Re: On-Going Services
Austin Colony Phase 1B Subdivision Improvement Plans – 1st Submittal Review
Angleton, Texas
HDR Job No. 10420700

HDR Engineering, Inc. (HDR) has reviewed the plans for the above referenced subdivision and offers the following comments:

PROPOSED GRADING

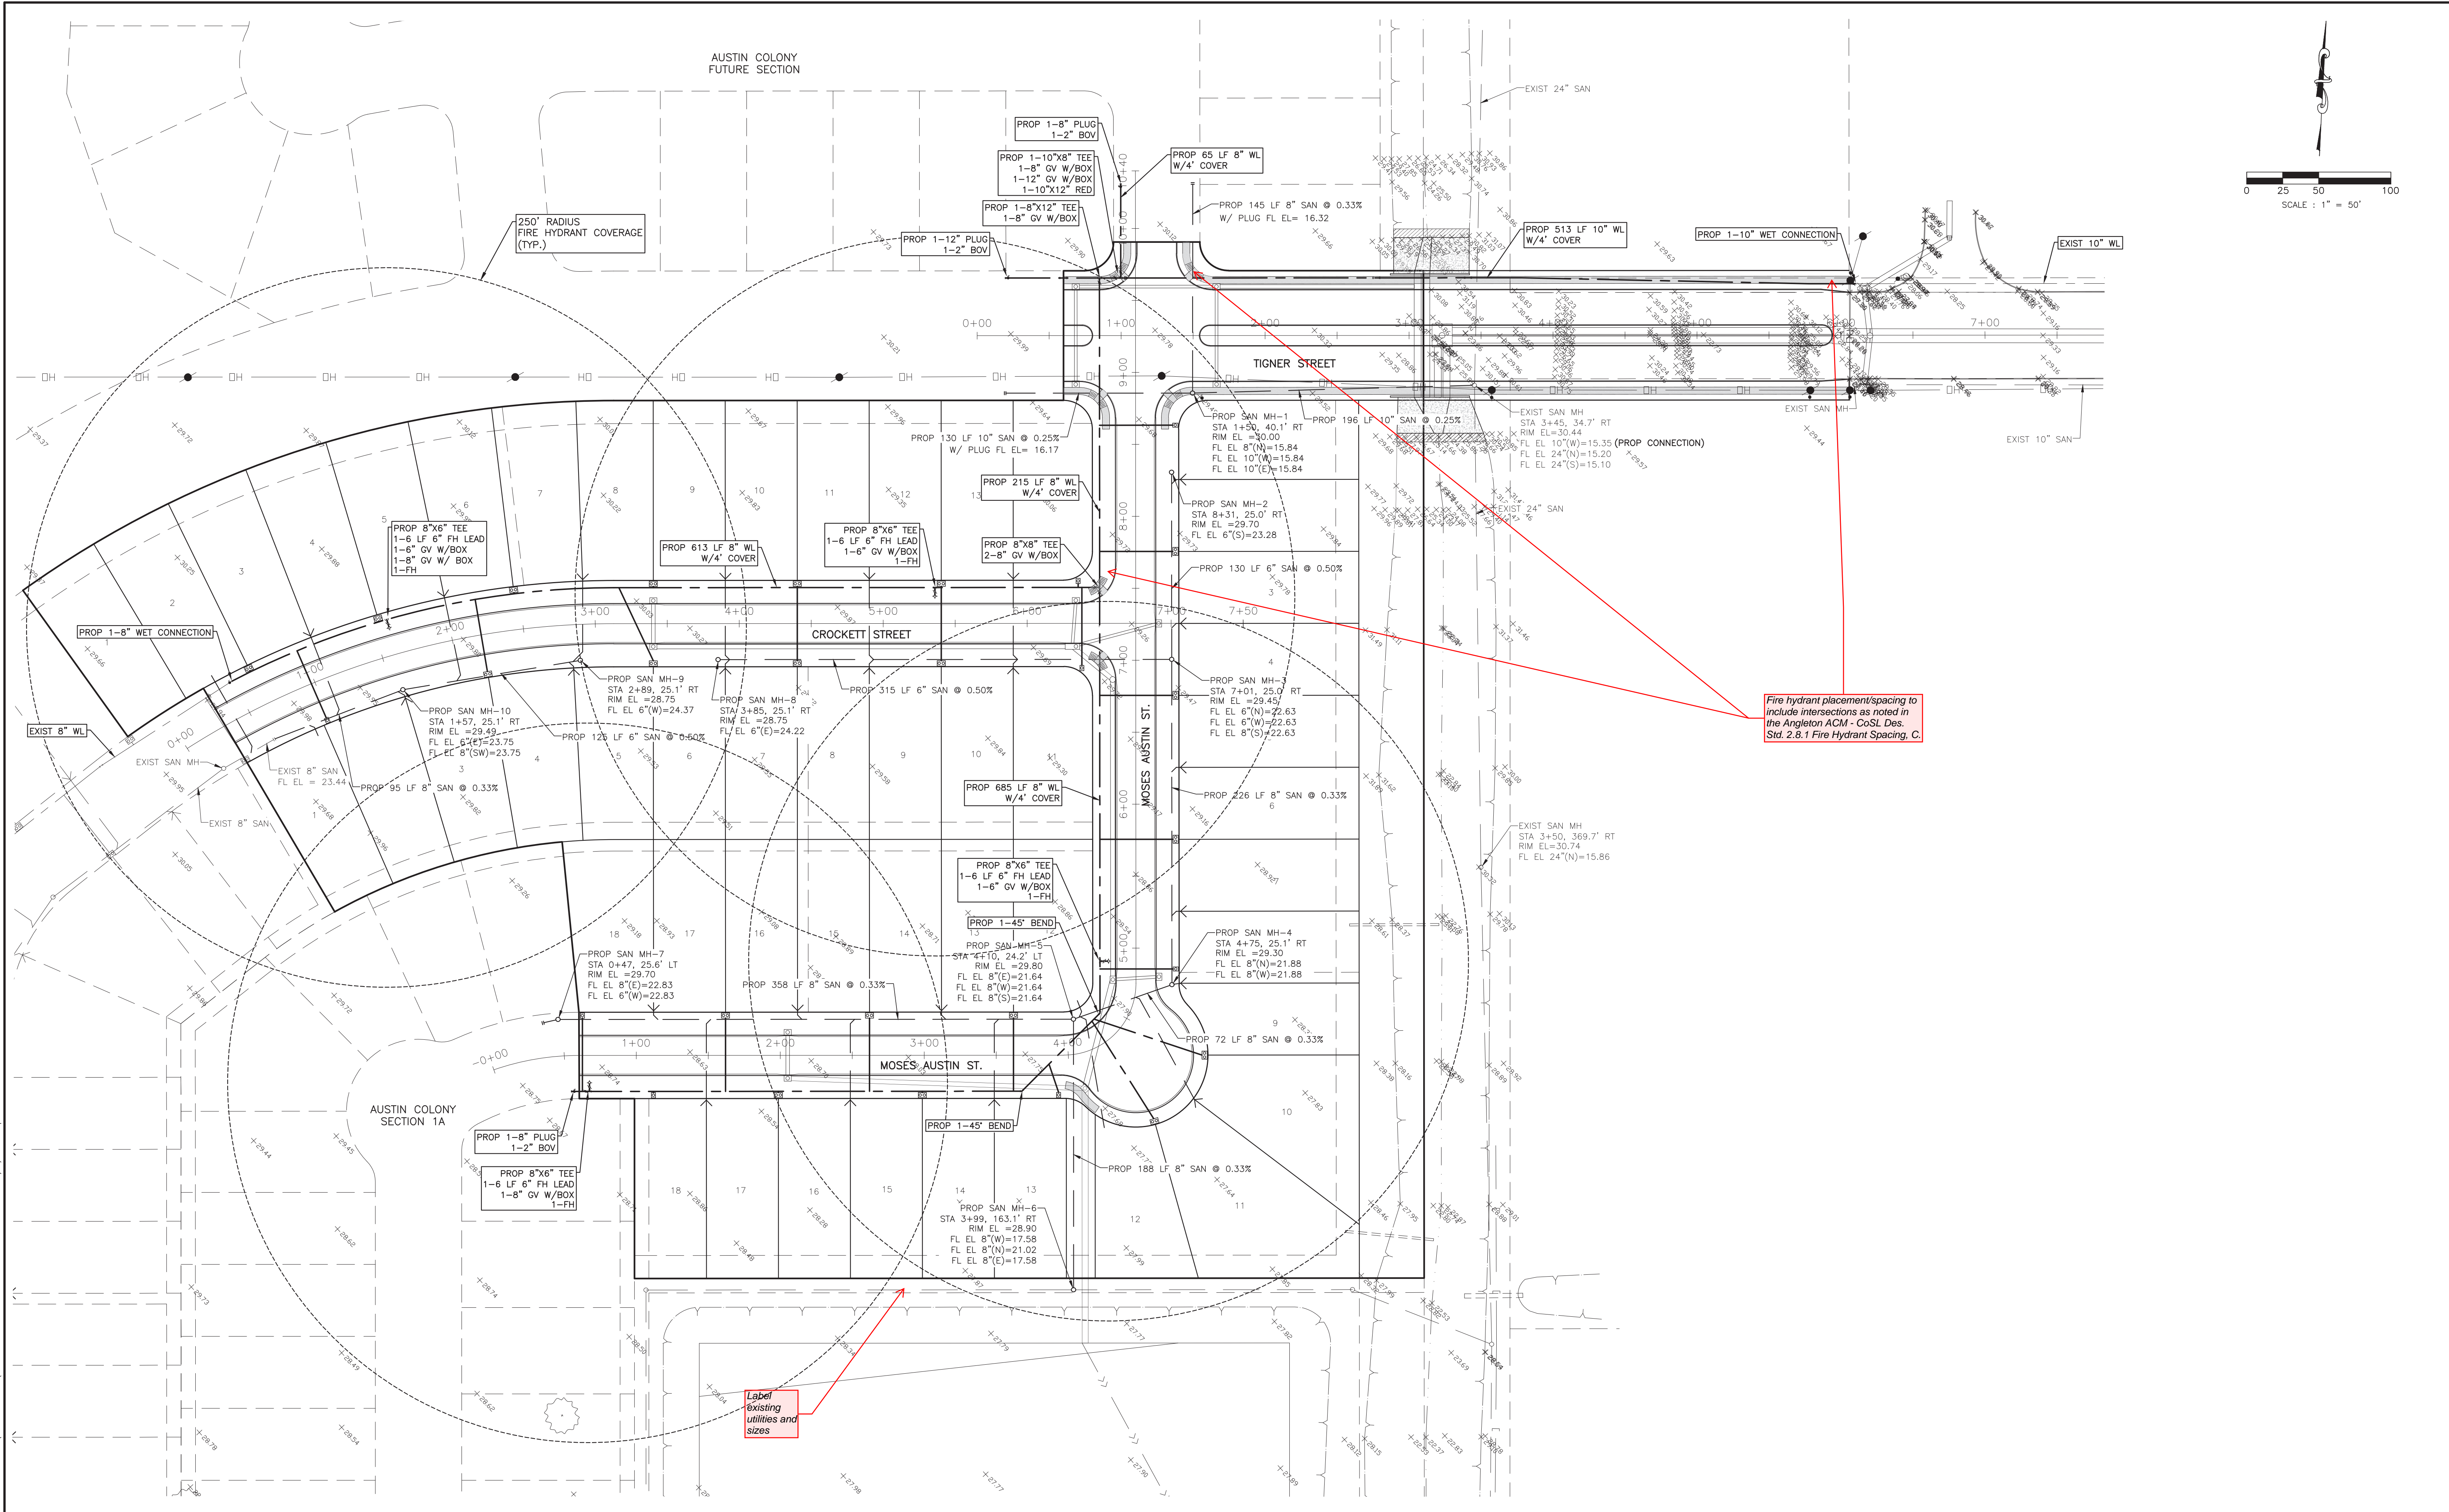
3. Sheet 6 of 50 - Street jogs (off-sets). Street off-sets less than 150 feet, measured centerline to centerline, are prohibited (Angleton LDC Sec. 23-12 F.4.

4. Sheet 6 of 50 - No proposed information shown in Sections
5. Sheet 7 of 50 - Fire hydrant placement/spacing to include intersections as noted in the Angleton ACM - CoSL Des. Std. 2.8.1 Fire Hydrant Spacing, C.

UTILITY LAYOUT
PROJECT NO. 16182

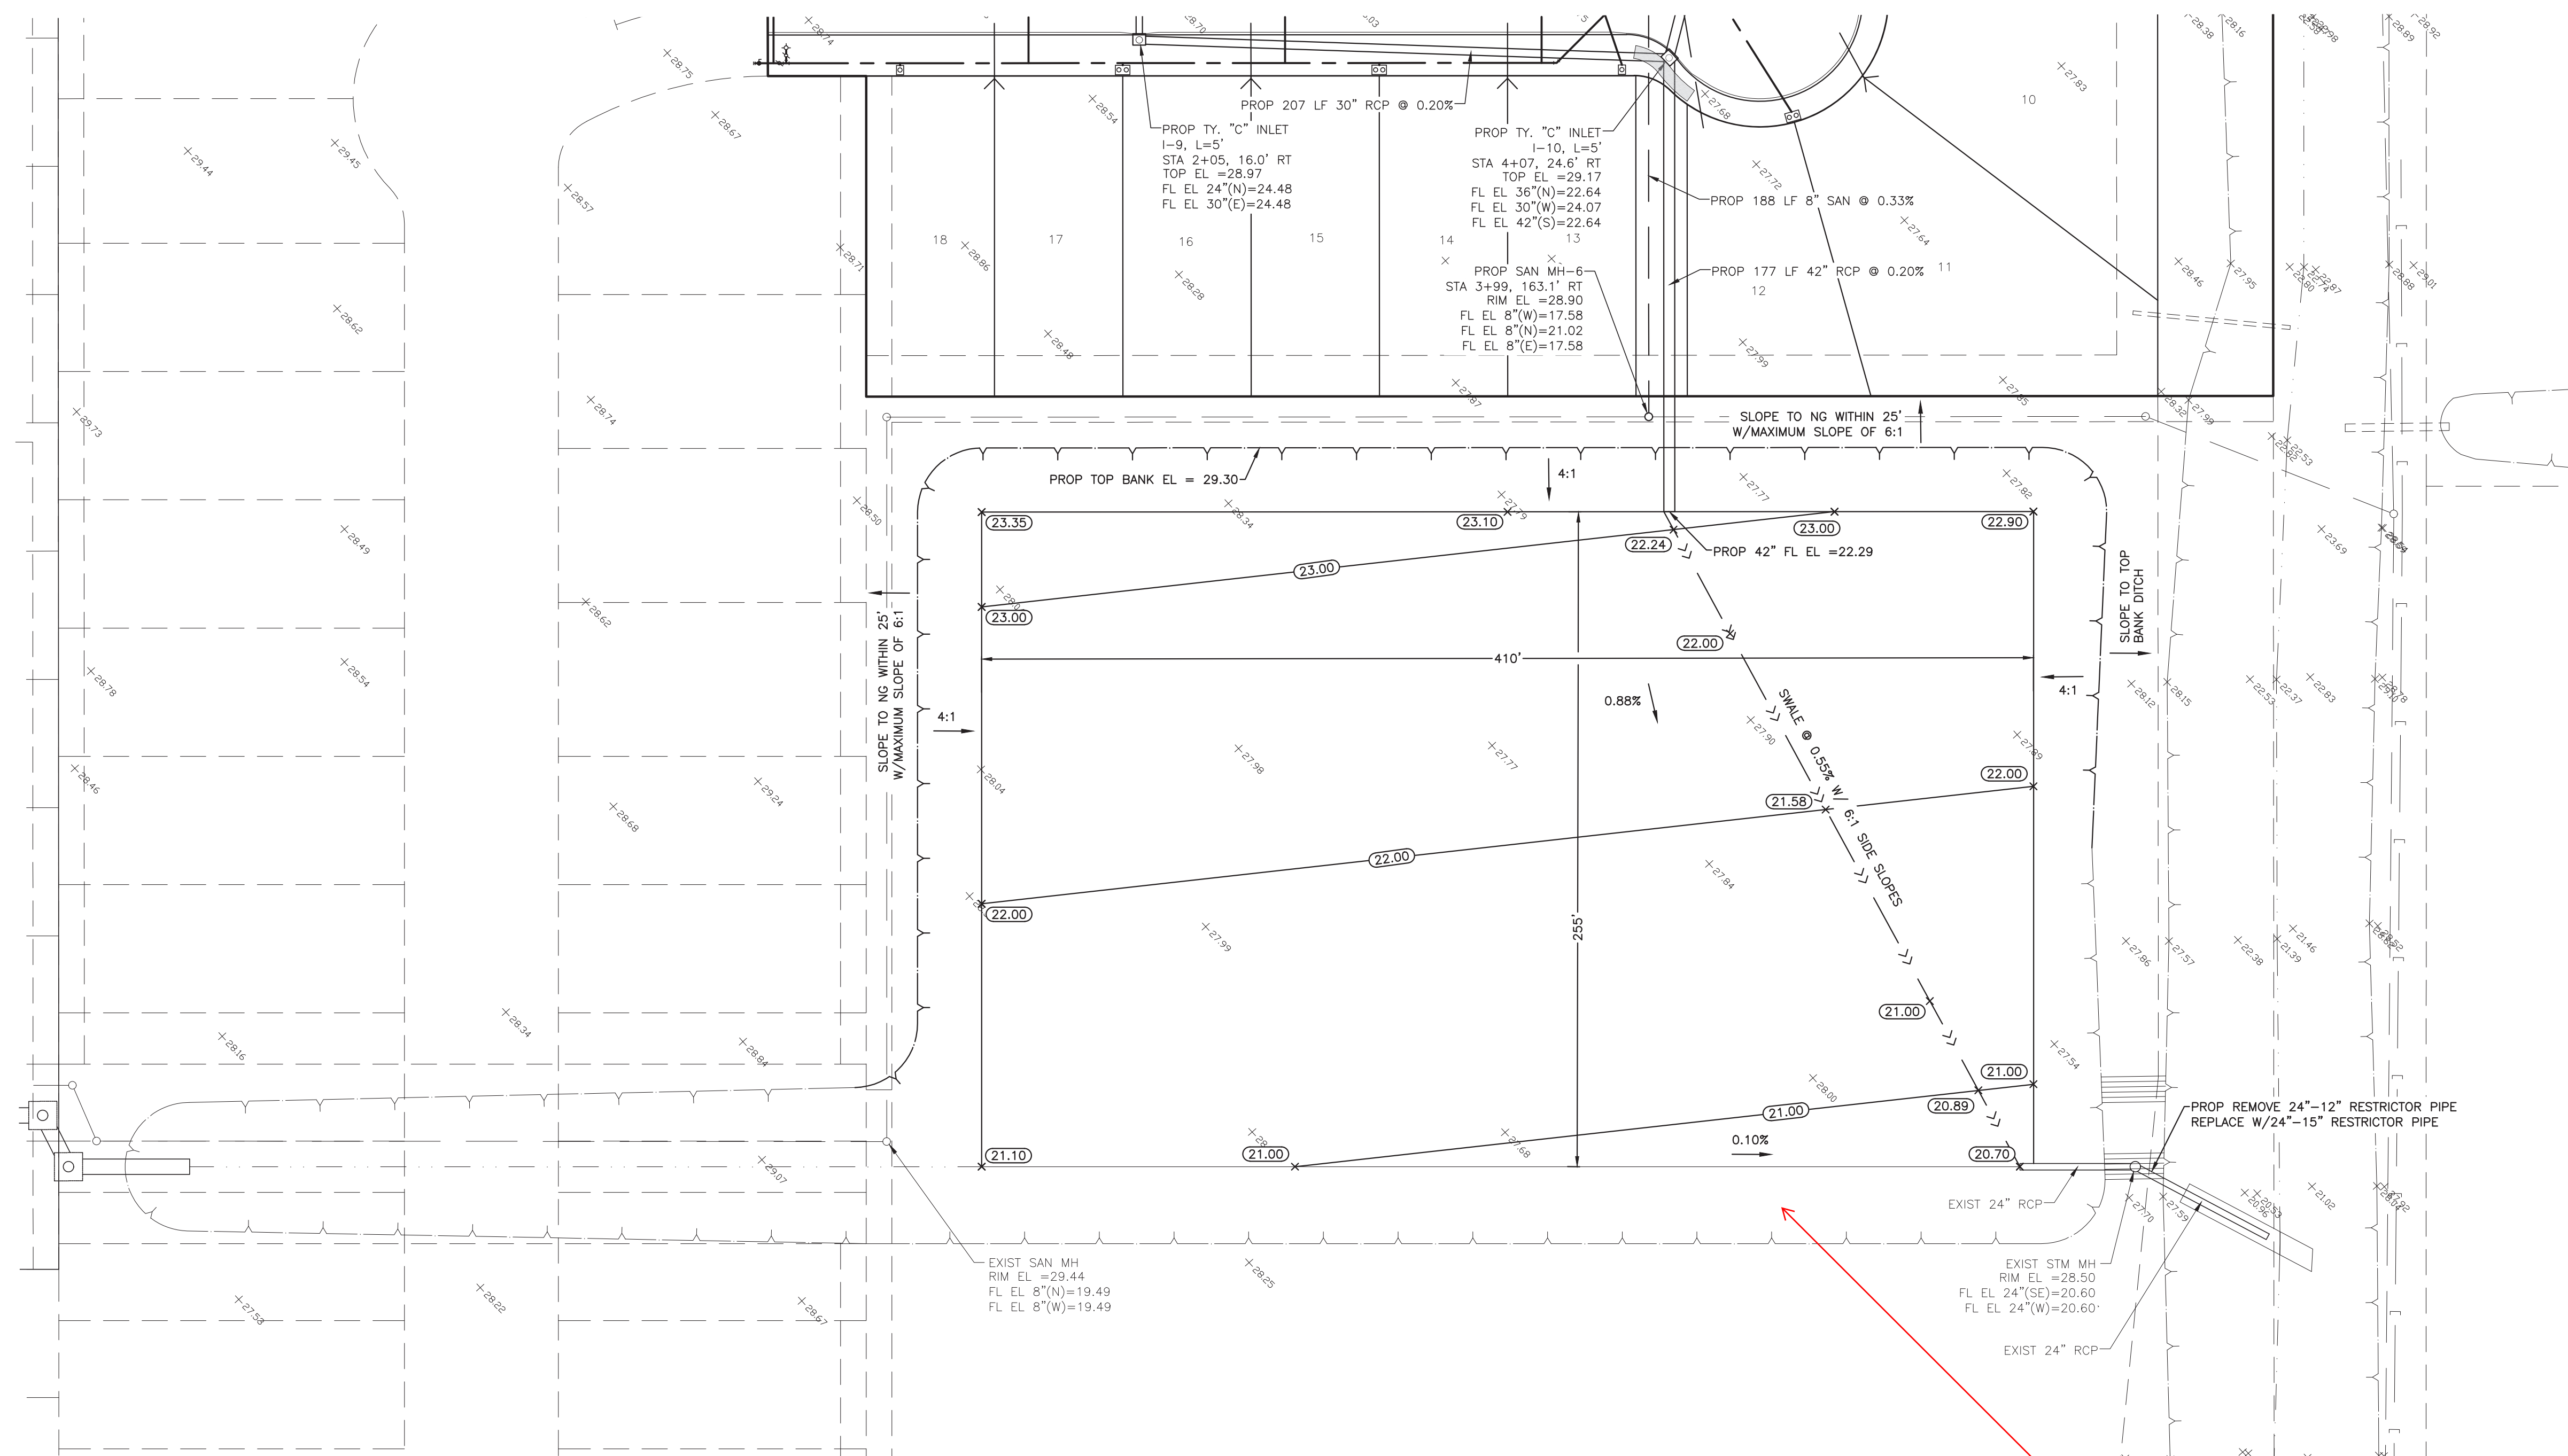
6. Sheet 7 of 50 - Label existing utilities and sizes
7. Sheet 8 of 50 - Please include the cross sections for the proposed pond as noted
8. Sheet 9 of 50 - Are these wall penetrations feasible at the inlets noted (I-10, I-5)
